Design Review Committee Meeting

700 Doug Davis Drive
Hapeville, GA 30354

December 16, 2020 6:00 PM

**DEPARTMENT OF PLANNING AND ZONING
PLANNER'S REPORT**

SITE PLAN PREPARED FOR:
VICKIE BARNES

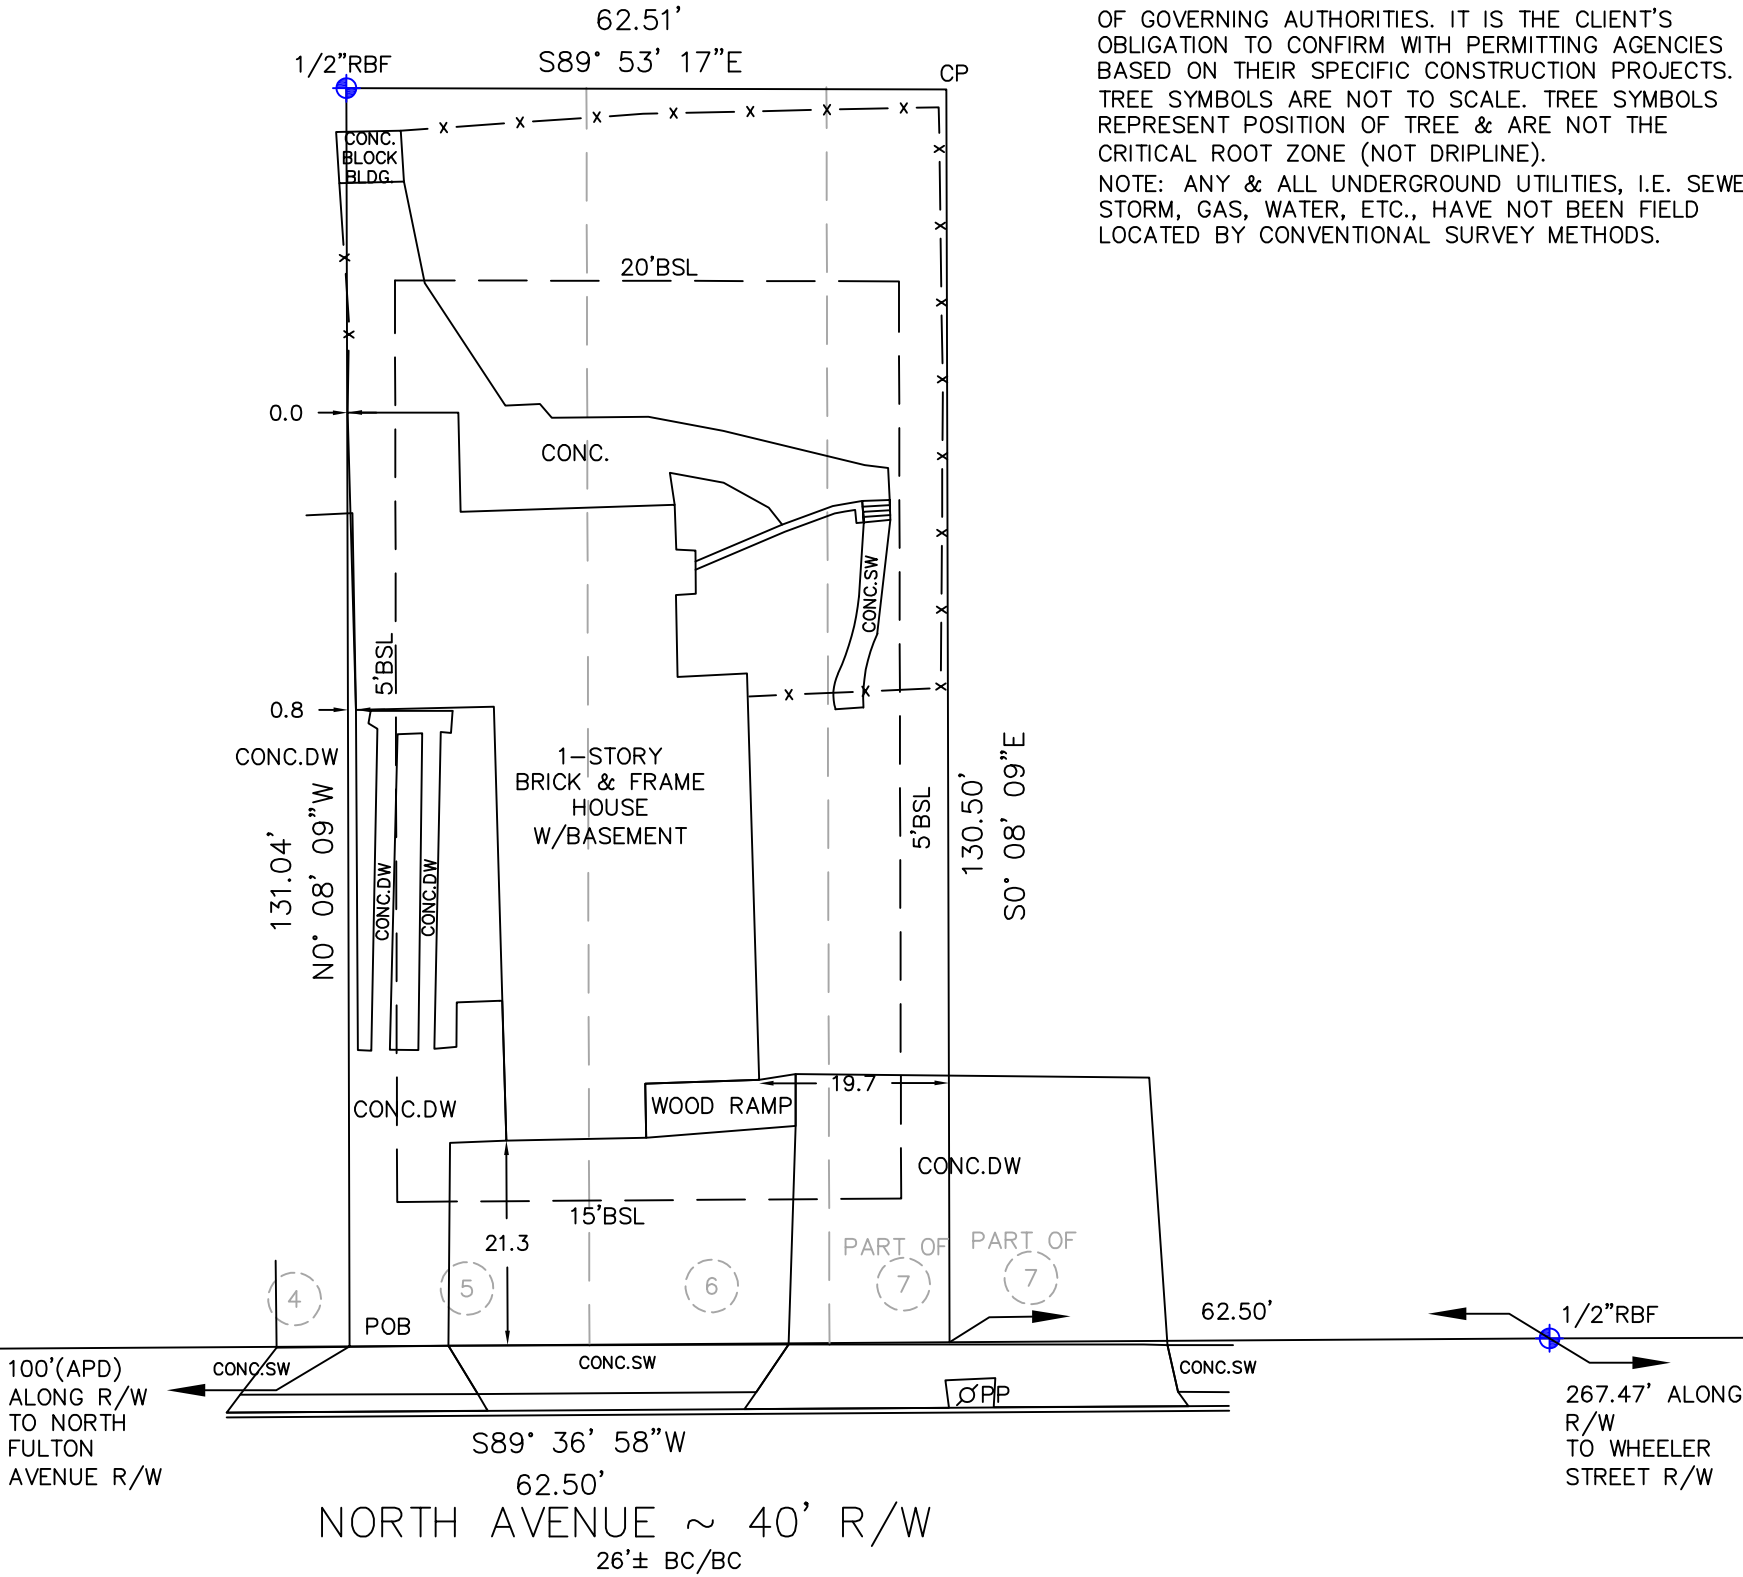
STAFF COMMENT: *The existing garage is located within the setback. It must be removed but is not clear from the drawings.
An existing sidewalk is shown on the site plan.*

STAFF COMMENT: Mechanical is located in front of a wooden fence. Must be screened.

STAFF COMMENT: Driveway width is not provided.

FRONT ELEVATION

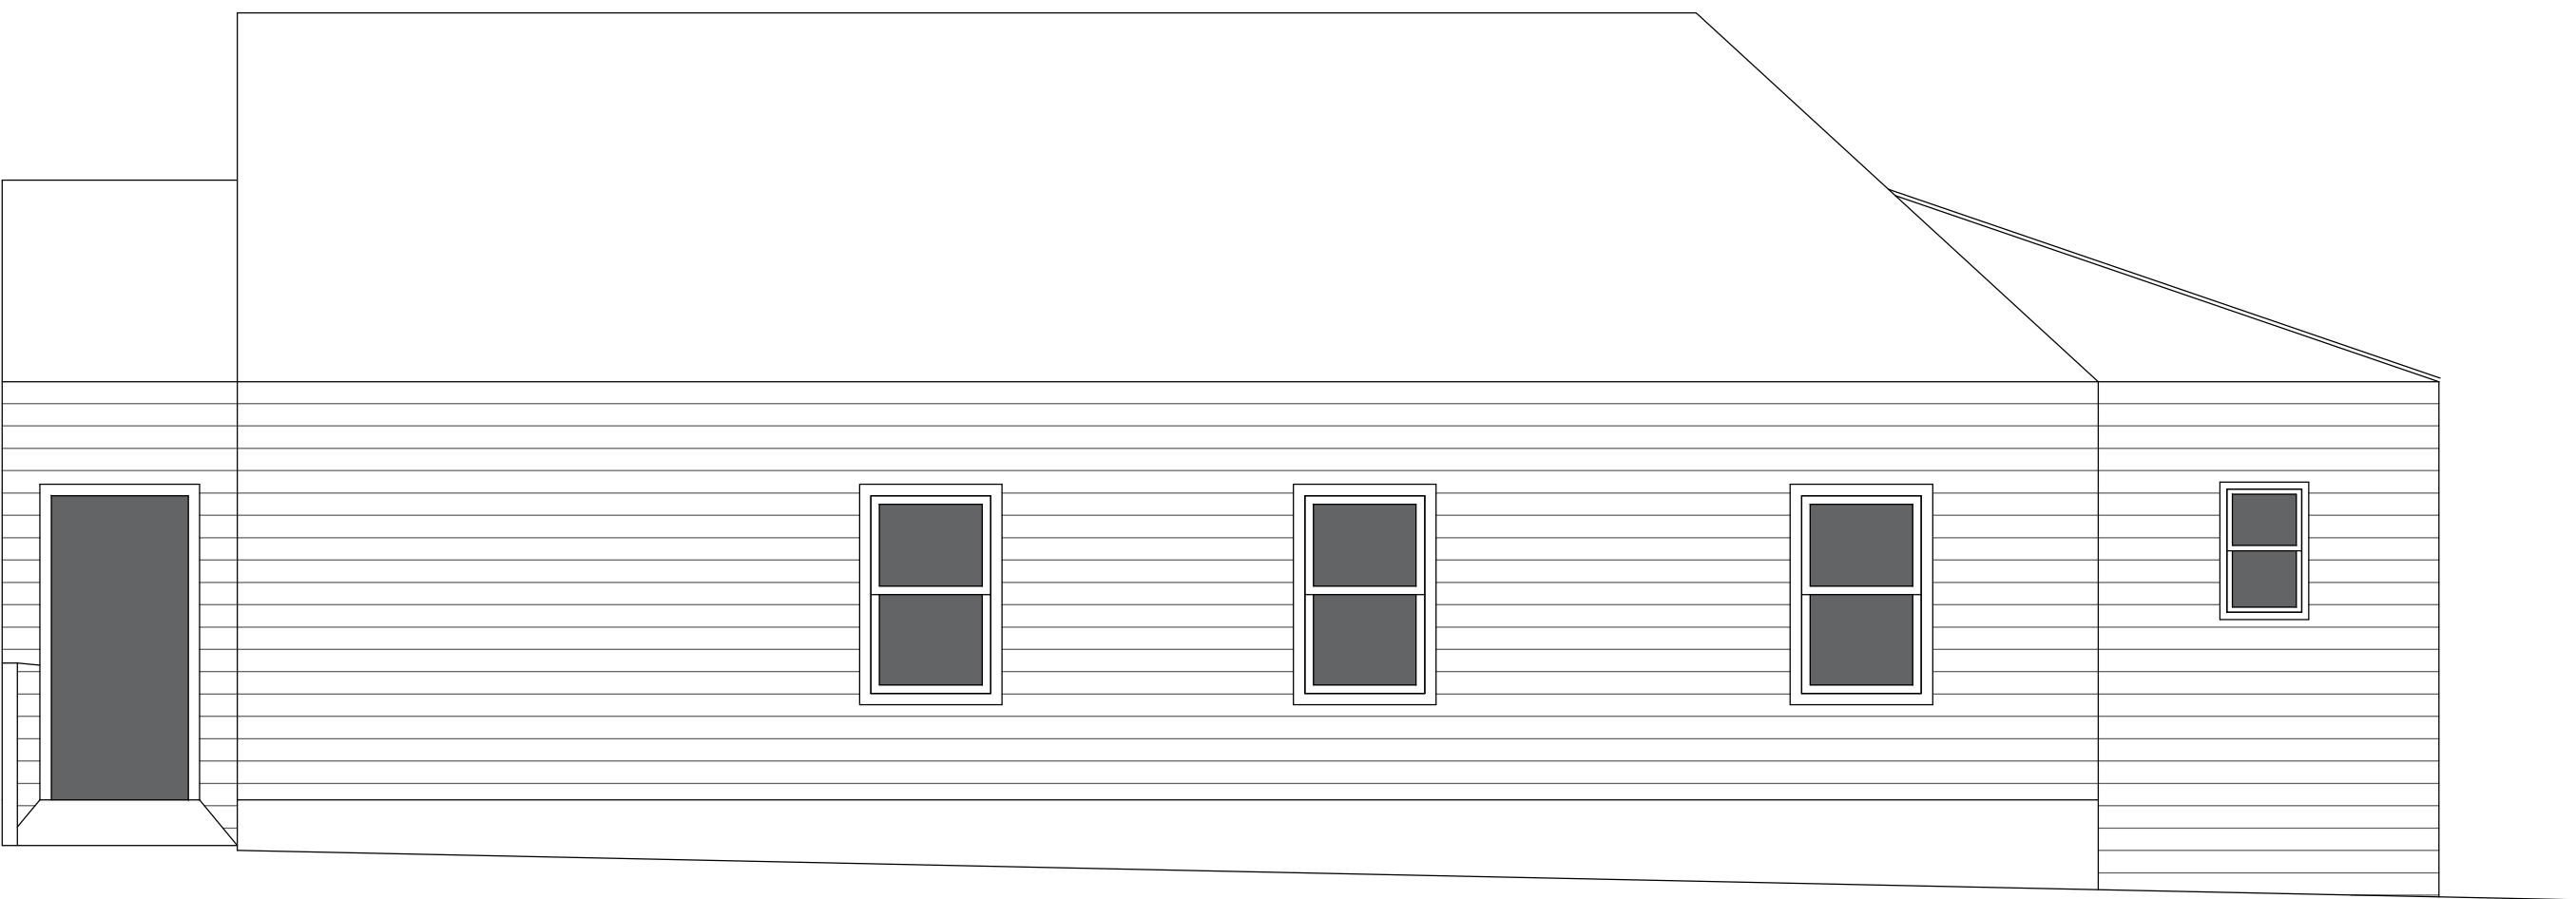
The as-built drawings do not represent the actual condition of the house, including the garage that is located within the setback. Not does the floor plan include the addition on the lower level at the rear of the dwelling. The rear elevation is not drawn correctly (per photos supplied.)

title: **PROPOSED**
project: MIGHTY ESTATES
493 NORTH AVENUE
HAPEVILLE, GA. 30308

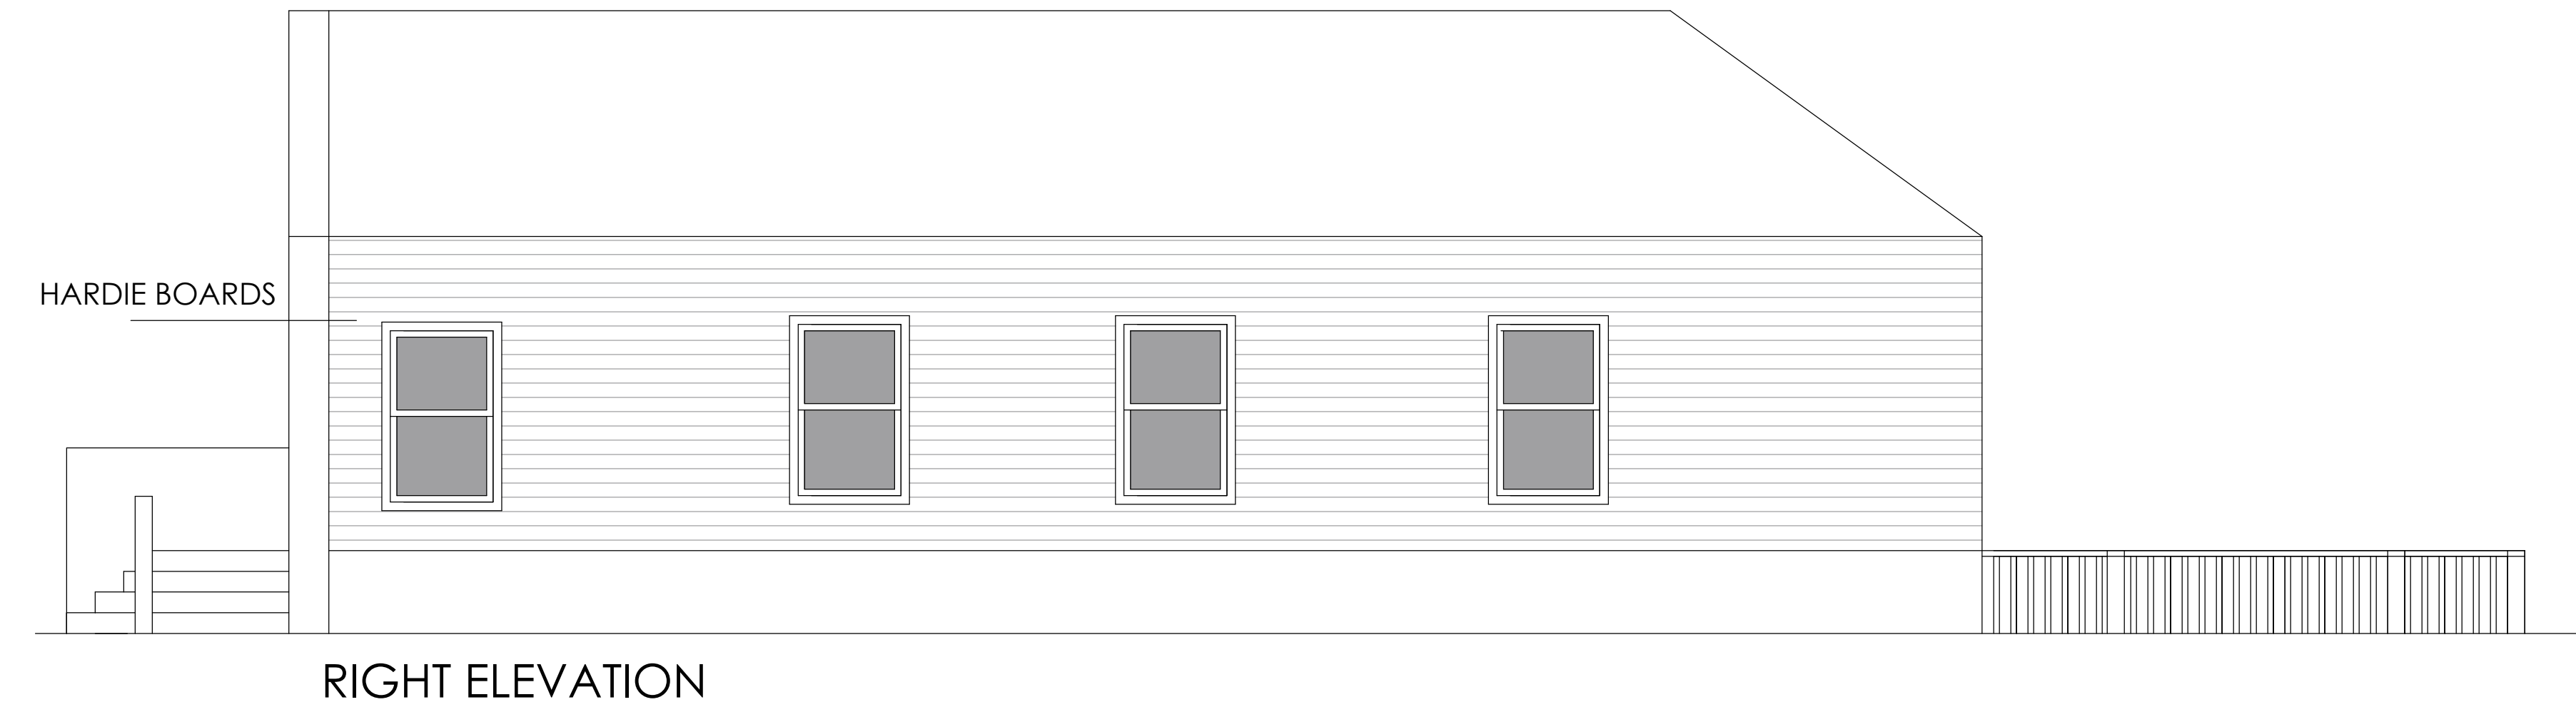
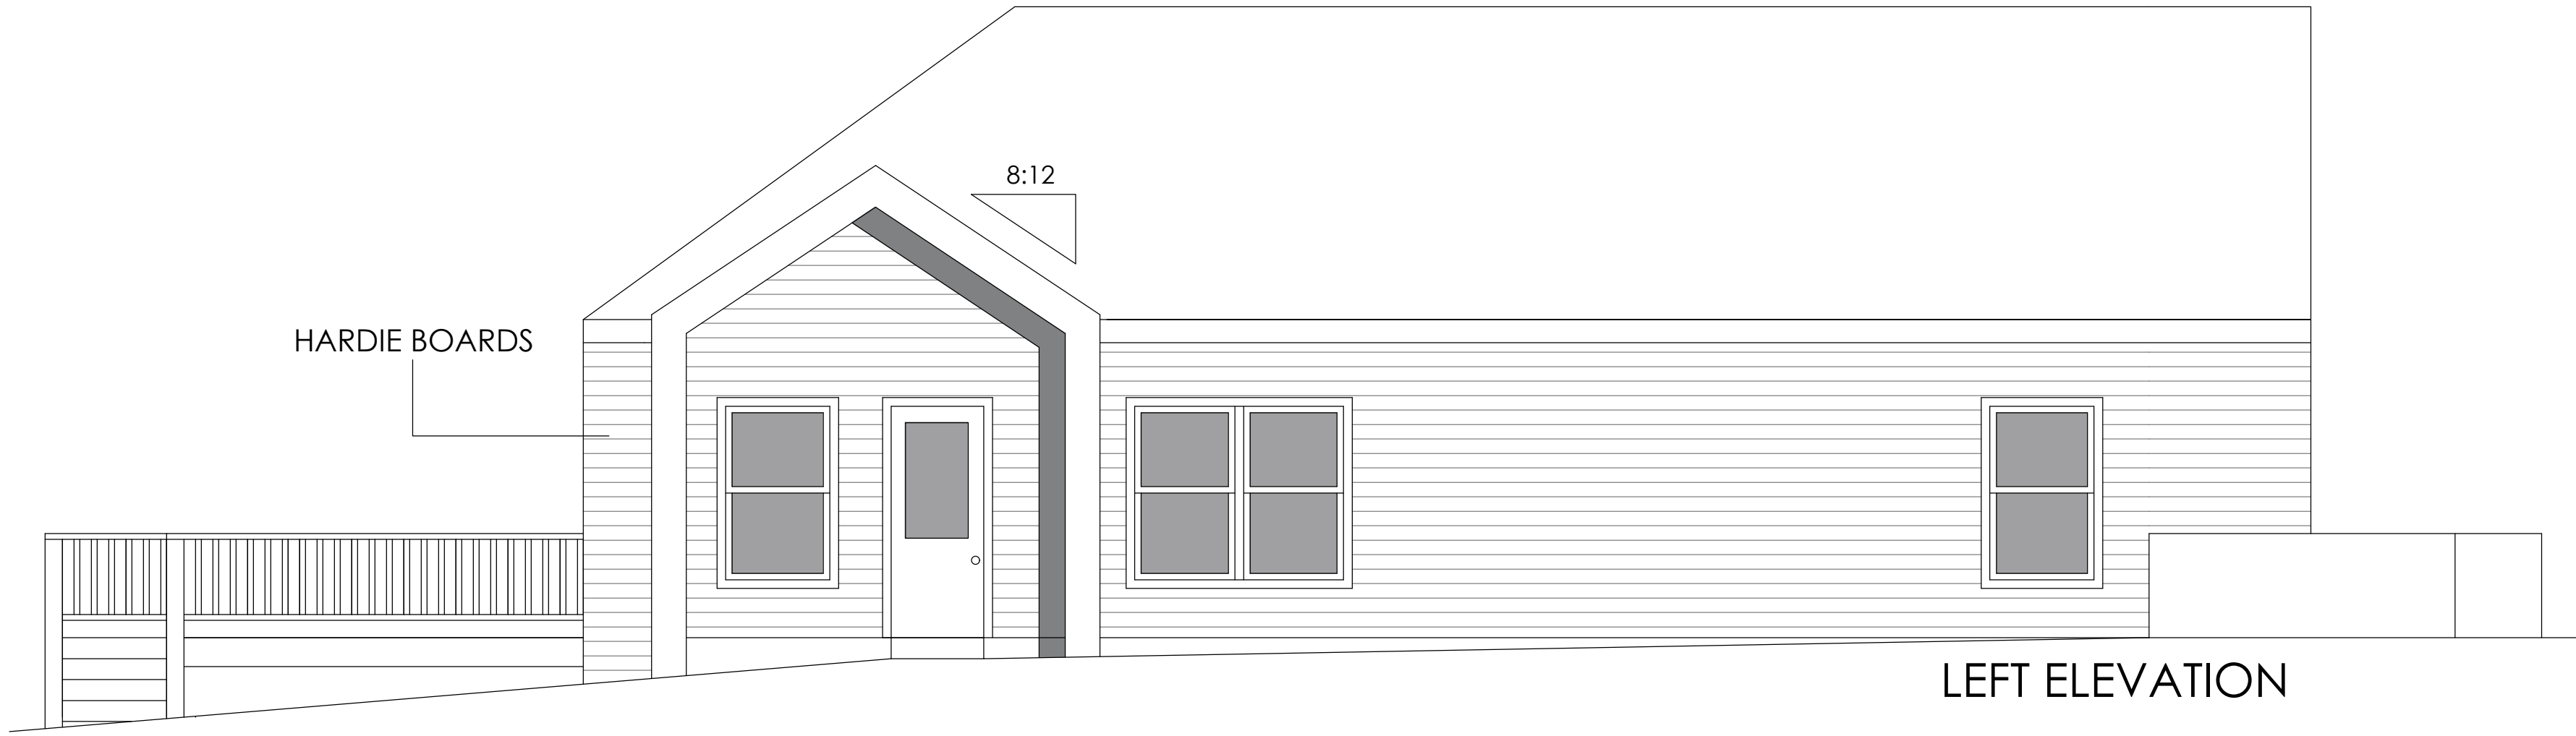
Hardi plank is indicated for the exterior façade material. The materials along the front façade are not clear.
